DEVIATION REQUEST AND DECISION FORM

Project Name : Grandwood Ranch
Schedule No.(s) : 6119000003
Legal Description : S2N2, EX PT TO HIGBY RD CONV BY REC# 205092691 W/MR SEC 19-11-66

DEV #5

PCD File No. SP-195

Deviation Exhibit 4
Grandwood Ranch (LSC# 185020)

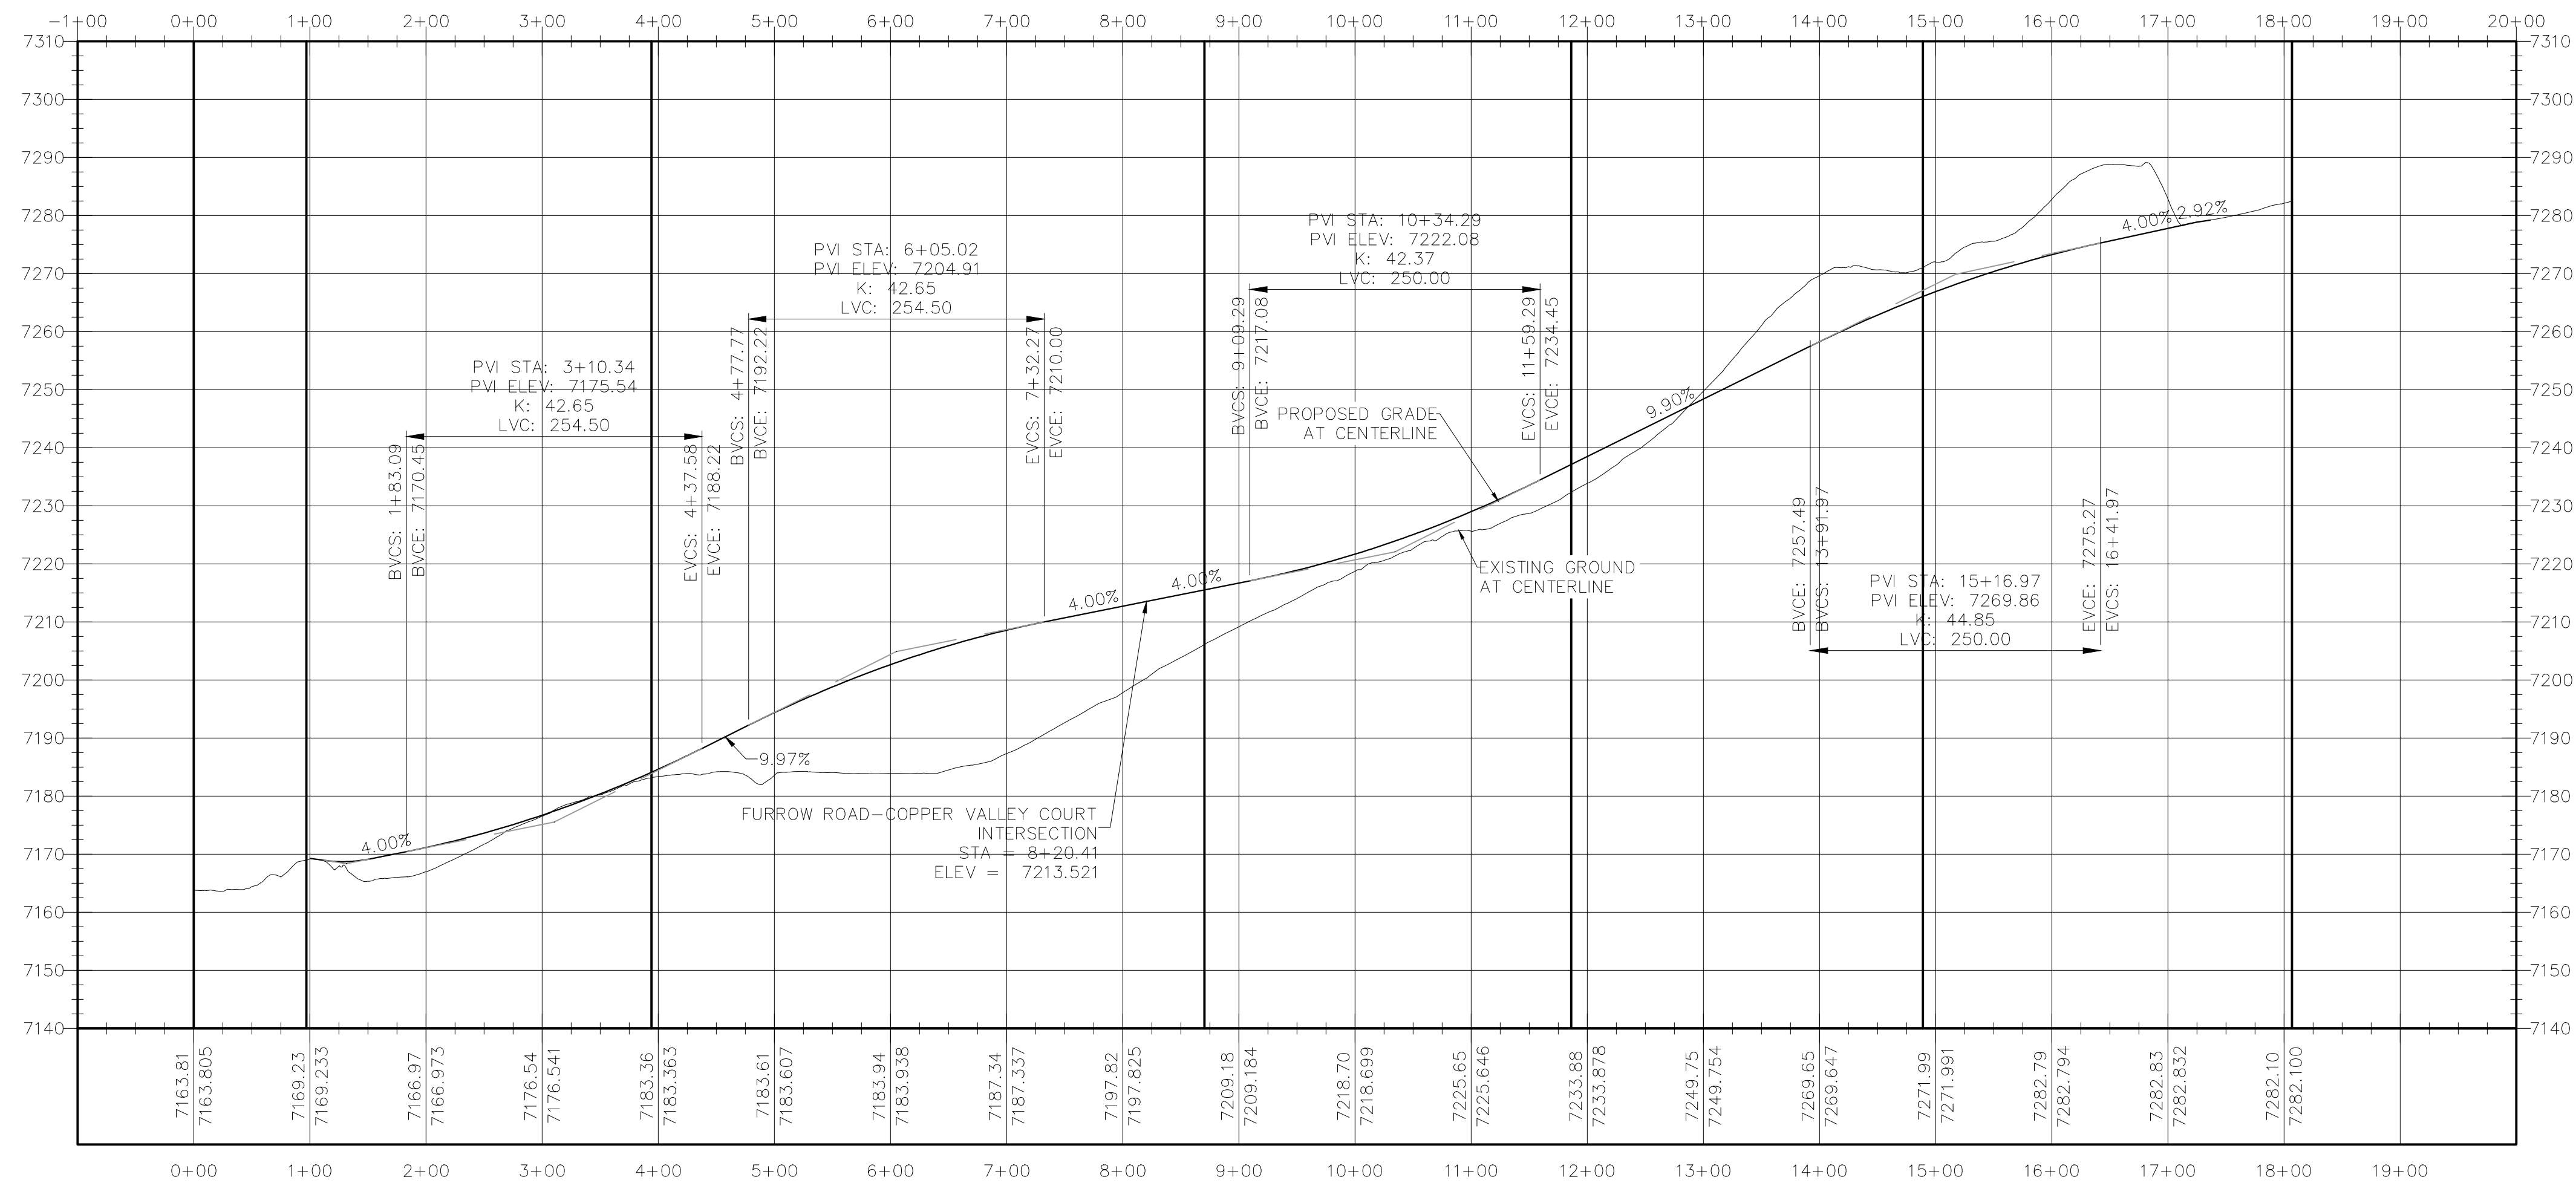
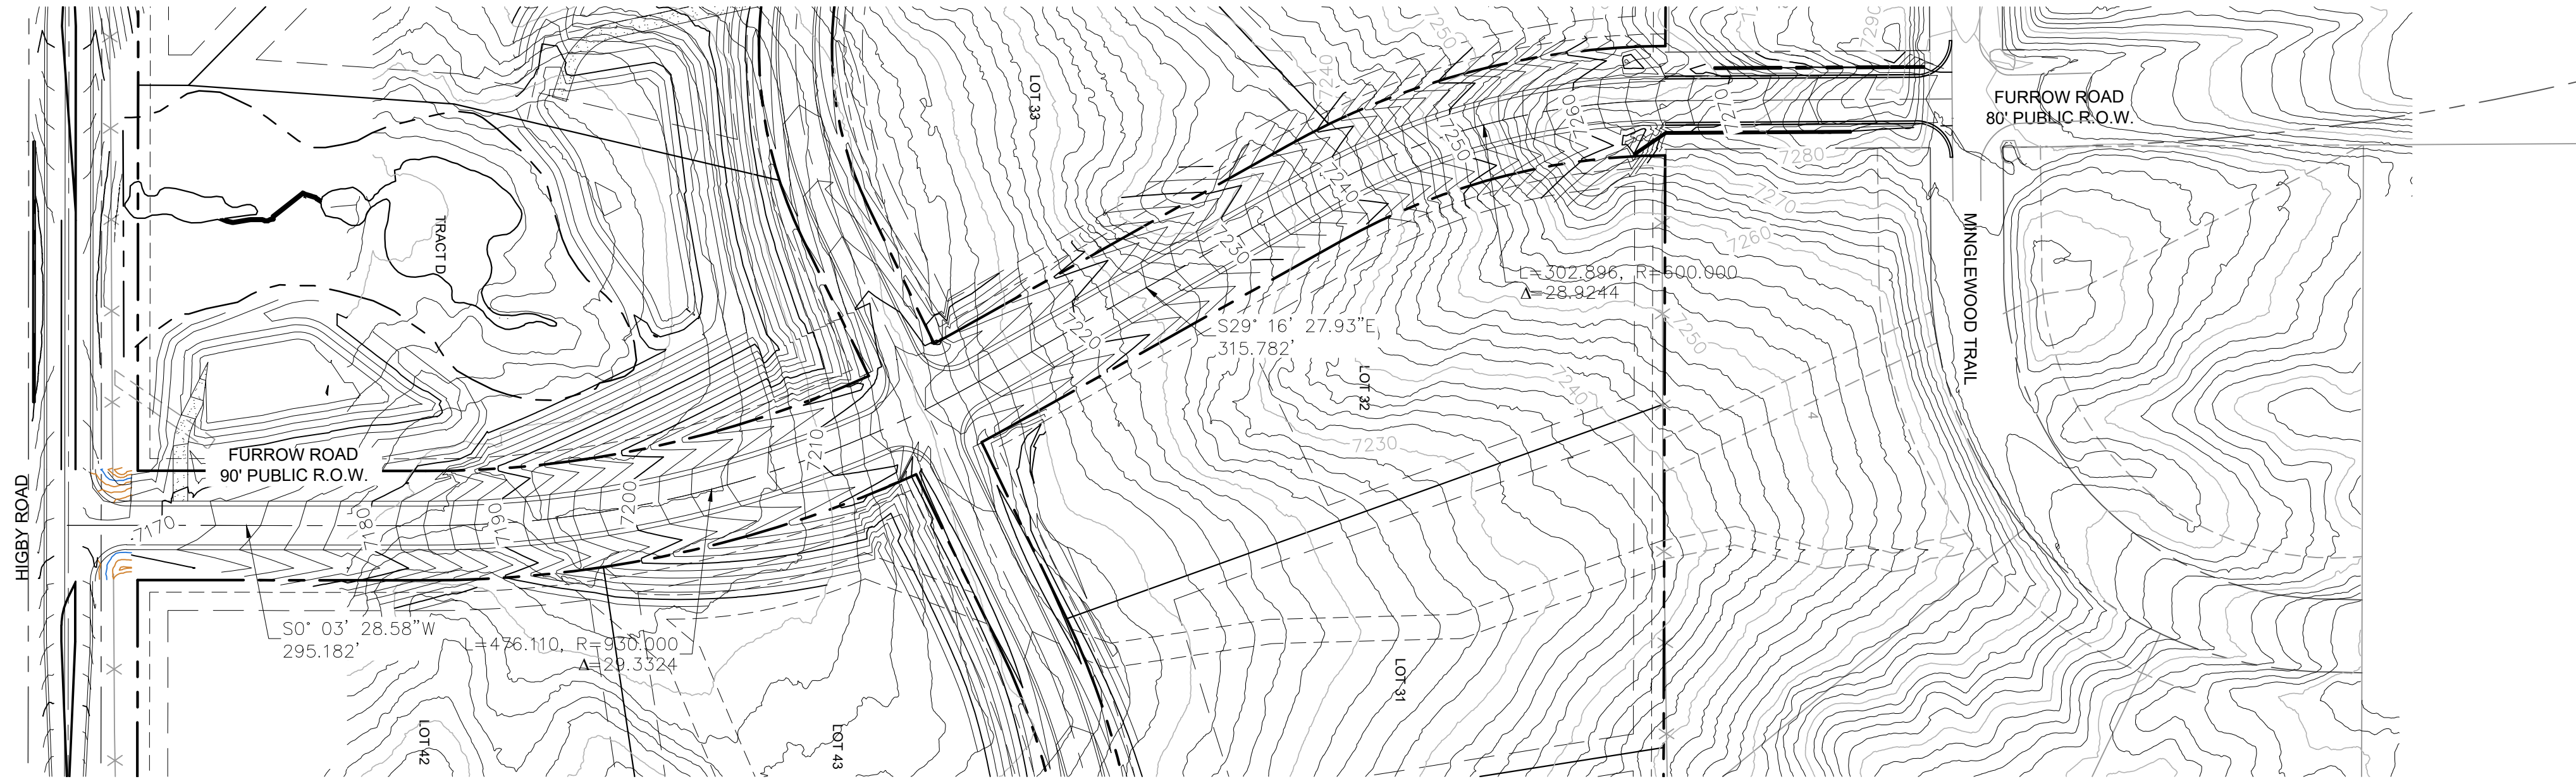
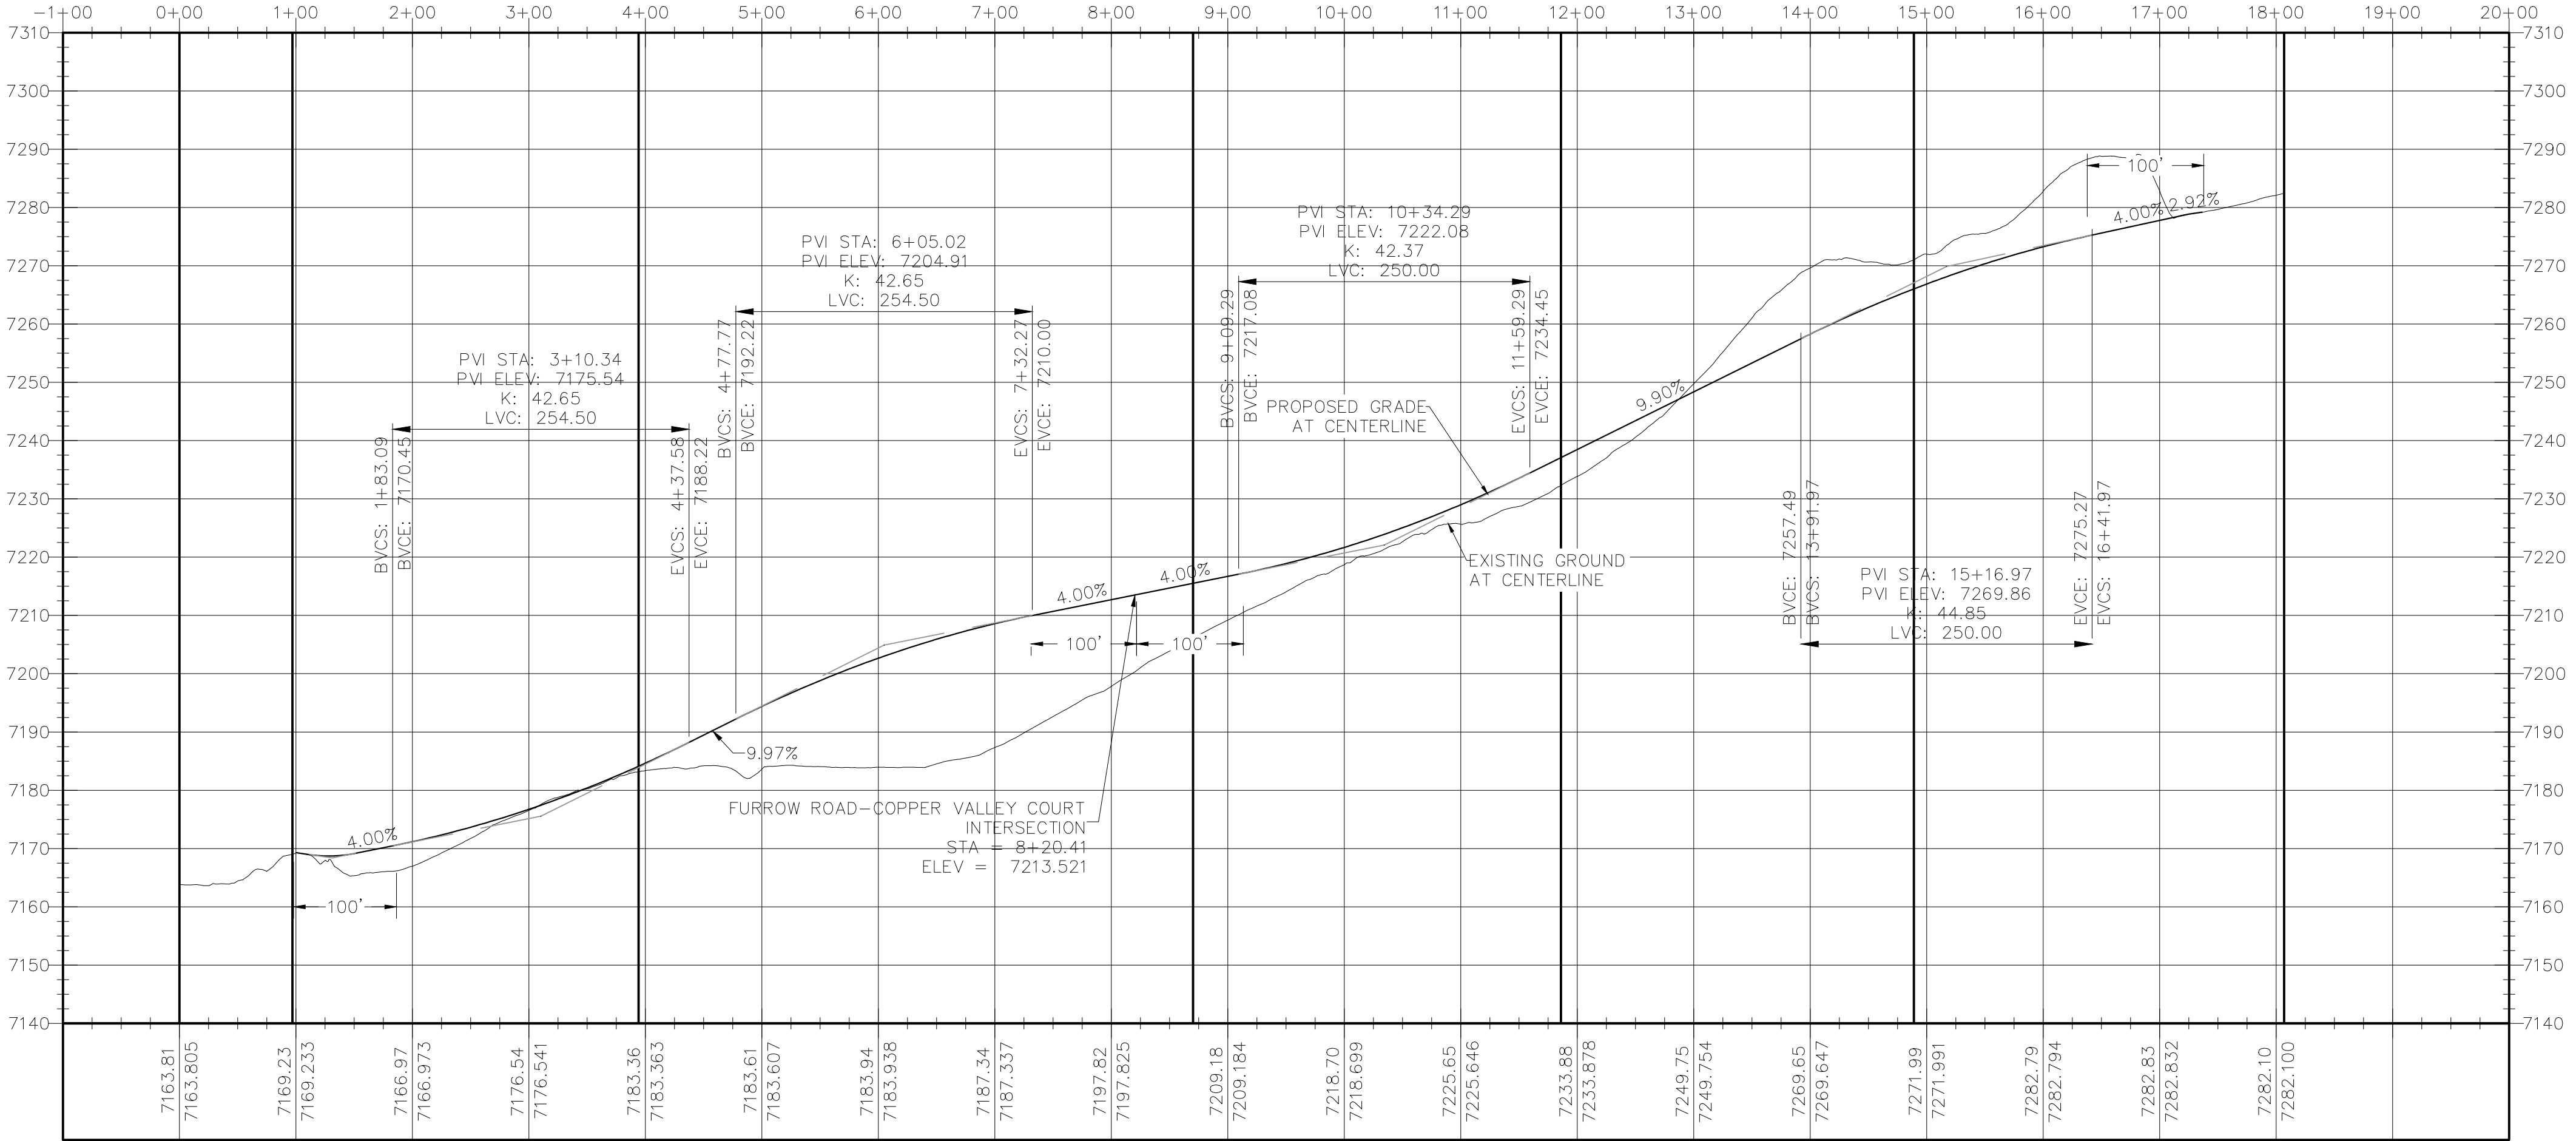
The following alternatives to Rural Major Collector standards are requested, per criteria in Table 2-5 of the ECM. Please refer to the LSC Exhibit No. 4 and the attached plan & profile exhibit by Matrix Design Group:

Note: This deviation is for the section from the Grandwood property line south to Higby Road. Please refer to the separate deviation prepared by Matrix Design Group for the section of Furrow just north of the Grandwood property line. **For reference only**, the following applies to the section north of the Grandwood property line in order to allow room for the construction of retaining walls and grading operations, a modified Rural Major Collector segment is proposed for the extents of improvements within the existing Timberview Subdivision, Filing 2. The proposed segment replaces the typical roadside swale with curb and gutter to properly convey stormwater runoff and to allow feasible space for retaining wall construction without disturbing adjacent property owners. Curb and gutter will also serve as protection against erosion at the base of the retaining walls. Once the Furrow Road extension reaches the Grandwood Ranch development site, the standard EPC Rural Major Collector cross-section will be assumed for the remainder of the roadway extension.

- Geometry previously shown with a 93-foot horizontal curve radius and 90-foot ROW resulted in public ROW encroaching into existing private lots within Timberview Subdivision. Please reference attached exhibit for further explanation on geometric constraints.

- Existing conditions along the Furrow Road alignment show approximately 113-feet of vertical fall resulting in an average 7% slope. With El Paso County criteria of 4% approach grade for 100-feet and, at a design speed of 40 mph, a K-value of 44 for crest curves and 64 for sag curves, there is not enough horizontal room to allow the vertical design of Furrow Road to meet Criteria completely. The attached exhibits provide a visual of the proposed vertical design with the approved deviation and with attempts at meeting Criteria. Using K-values with the proposed Furrow Road results in short and steep tangent sections between curves that exceed maximum limits and does not allow for proper approach grades at intersections for the required distance.
